SUBJECT: ISSUANCE OF AMENDMENT NO. 29 TO FACILITY OPERATING LICENSE
 NO. NPF-41, AMENDMENT NO. 16 TO FACILITY OPERATING LICENSE
 NO. NPF-51, AND AMENDMENT NO. 4 TO FACILITY OPERATING LICENSE
 NO. NPF-74, FOR THE PALO VERDE NUCLEAR GENERATING STATION, UNITS
 1, 2 AND 3, RESPECTIVELY, (TAC NOS. 66798, 66799 AND 66800)

The Amendments revise Section 6 of the Technical Specifications for each of the three Palo Verde Units to incorporate changes reflecting a revised organizational structure for the Palo Verde plant.

SAFETY EVALUATION BY THE OFFICE OF NUCLEAR REACTOR REGULATION
RELATED TO AMENDMENT NO. 29 TO FACILITY OPERATING LICENSE NO. NPF-41,
AMENDMENT NO. 16 TO FACILITY OPERATING LICENSE NO. NPF-51
AND AMENDMENT NO. 4 TO FACILITY OPERATING LICENSE NO. NPF-74
ARIZONA PUBLIC SERVICE COMPANY, ET AL.
PALO VERDE NUCLEAR GENERATING STATION, UNIT NOS. 1, 2 AND 3
DOCKET NOS. STN 50-528, STN 50-529 AND STN 50-530

OFFSITE
ORGANIZATION
Figure 6.2-1

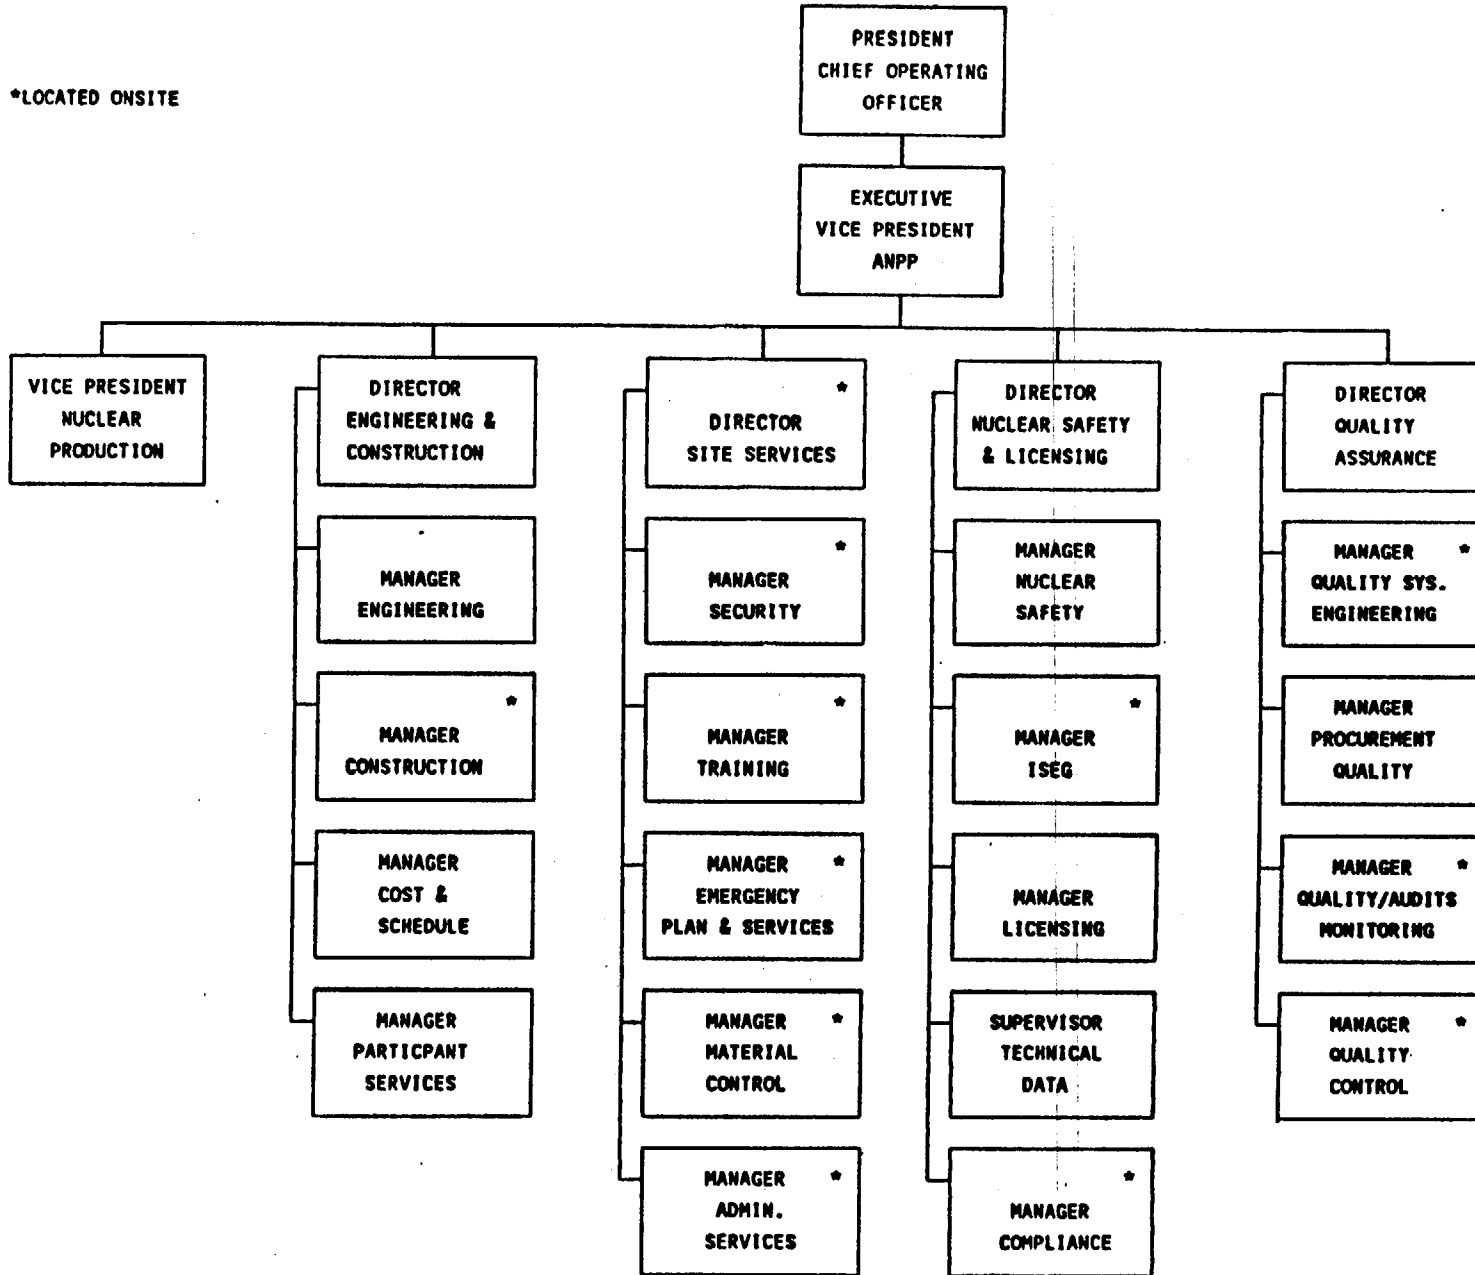
The proposed change requests an amendment to the Palo Verde Units 1, 2 and 3 Technical Specifications, Section 6, Figures 6.2-1 and 6.2-2, "Offsite Organization" and "Onsite Unit Organization." The change is administrative in nature in that the Manager of Nuclear Fuels will now report to the Vice President of Nuclear Production in lieu of reporting to the Director of Engineering and Construction. The change is intended to facilitate communications between the management of the Arizona Nuclear Power Project and the nuclear fuel supply vendor.

The staff has evaluated the proposed change and finds that the change should enhance management effectiveness with regards to fuel management. The Nuclear Fuels Department is responsible for fuels management and core analysis for the Palo Verde Units. The Manager of Nuclear Fuels provides nuclear fuel design, contracting and utilization expertise, nuclear fuel core and plant transient and accident analysis, and alternative core operating strategies. The areas of responsibility will remain the same.
